**TECHNICAL MEMORANDUM 002
POTENTIAL CPC MODIFICATIONS
EAST HARLEM NEIGHBORHOOD REZONING
CEQR No. 17DCP048M**

ULURP Nos.: N170359 ZRM, N170359(A) ZRM, C170358 ZMM,
and C170360 HUM
September 29, 2017

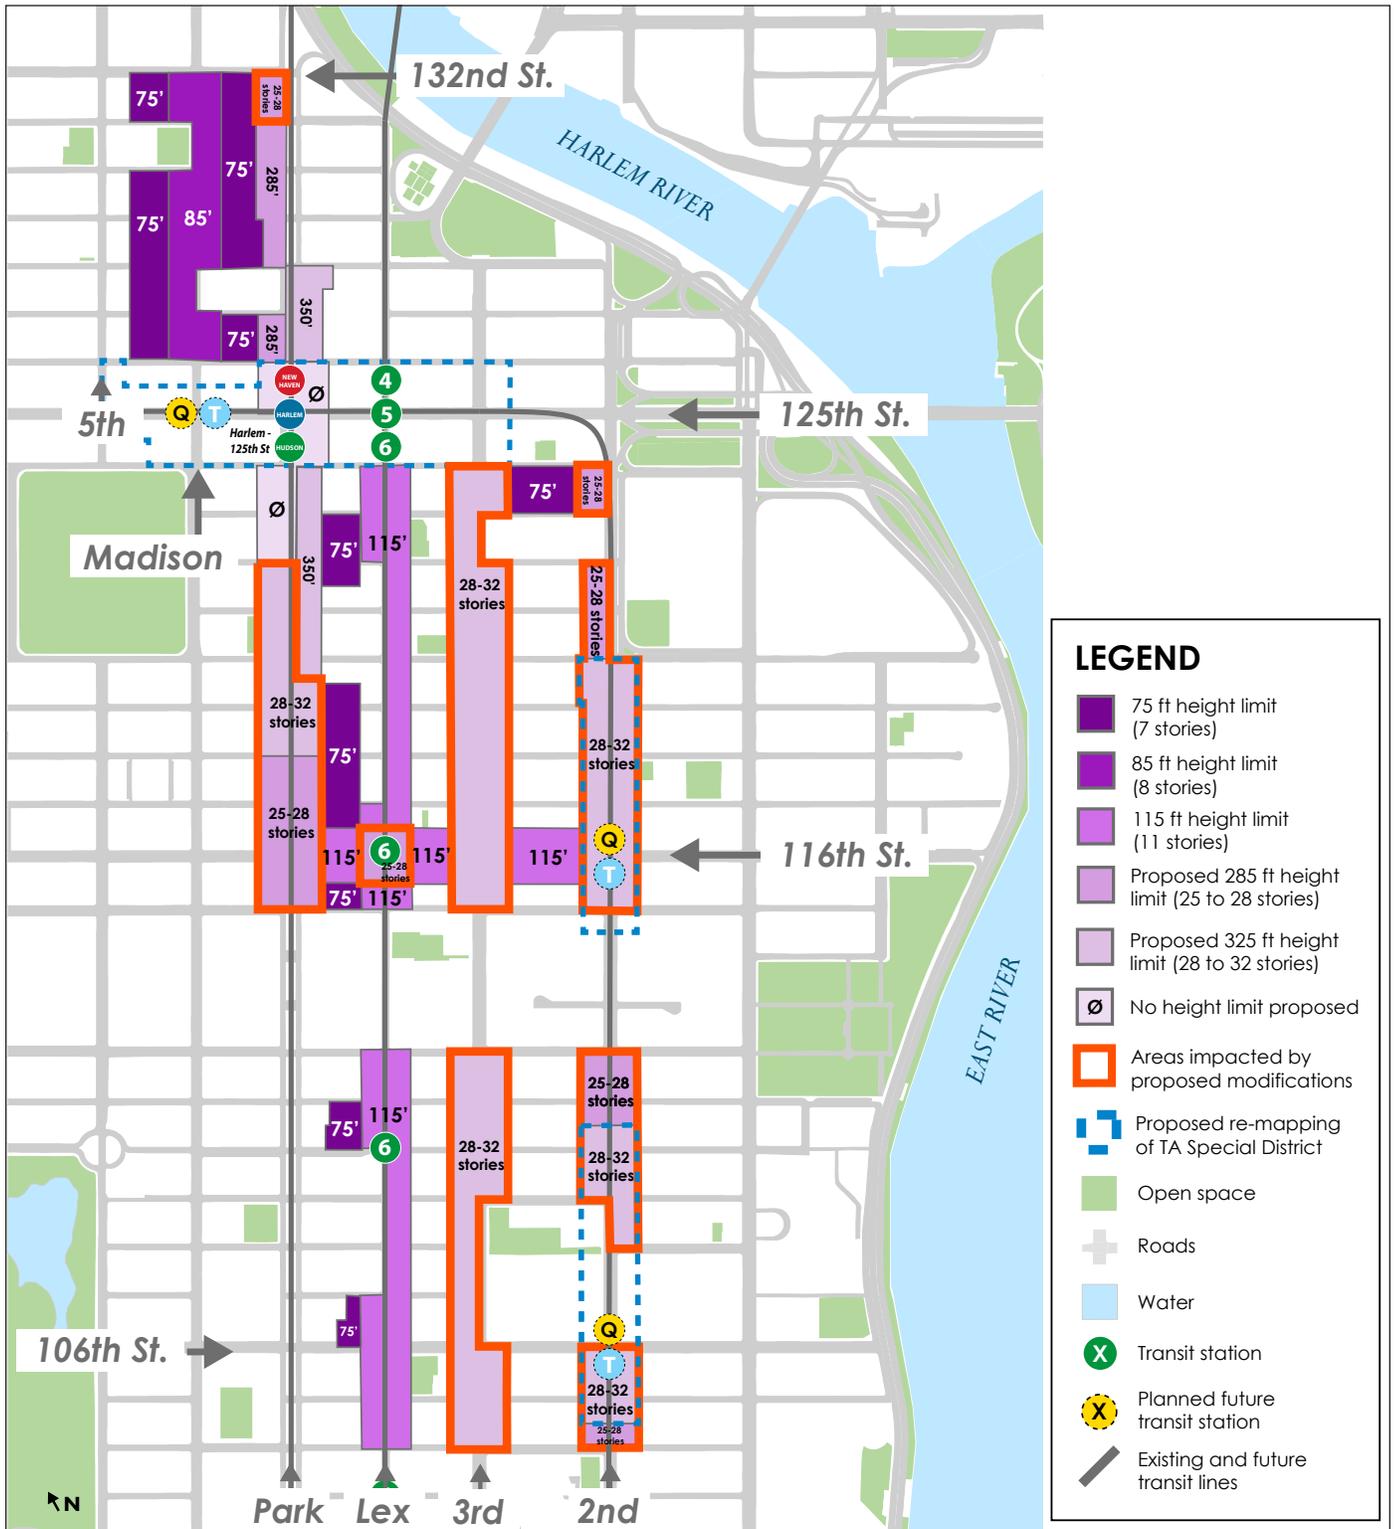
The Potential CPC Modifications propose height limits in districts that do not have height restrictions under the Proposed Actions, with the exception of the proposed C6-4 district near the transit hub at Park Avenue Corridor and East 125th Street. The Potential CPC Modifications would establish maximum height limits along the Park, Second, and Third Avenue Corridors and along Lexington Avenue at the intersection of East 116th Street (see **Figure 1** and **Table 1**).

A maximum building height limit of 285 feet is proposed along R9 portions of Park Avenue between East 115th and East 118th Streets, and in certain areas of the corridor between East 131st and East 132nd Streets. A maximum building height of 325 feet (28 to 32 stories) is proposed for R10 portions of the Park Avenue Corridor between East 118th Street and East 122nd Street. The C6-4 district proposed to be mapped along Park Avenue between East 122nd and East 124th Streets would continue to have no height restrictions.

A maximum building height limit of 285 feet is proposed within the R9 zoning district located at the intersection of East 116th Street and Lexington Avenue. Buildings located at this intersection would be approximately 25 to 28 stories.

The Potential CPC Modifications would restrict building heights in the proposed R10 district and the proposed C4-6 district (an R10 equivalent district) to 325 feet (28 to 32 stories). Along Third Avenue, the Proposed Actions would rezone the southern portion of the Third Avenue Corridor, between East 104th Street and East 112th Street, to an R10 district and in the northern portion of the corridor, between East 115th Street and East 124th Street, to a C4-6 district (R10 equivalent

A maximum building height of 325 feet (28 to 32 stories) is proposed within the R9 district that includes the Special Transit Land Use District (TA) along Second Avenue. The modification would provide developments within the TA the flexibility to accommodate subway infrastructure and required non-residential floor area. The Potential CPC Modifications would result in buildings of 28 to 32 stories between East 104th Street and 106th Street, between East 108th Street and East 110th Street, and between East 115th Street and East 120th Street. The remaining R9 district proposed along Second Avenue would have maximum building heights of 285 feet (25 to 28 stories).
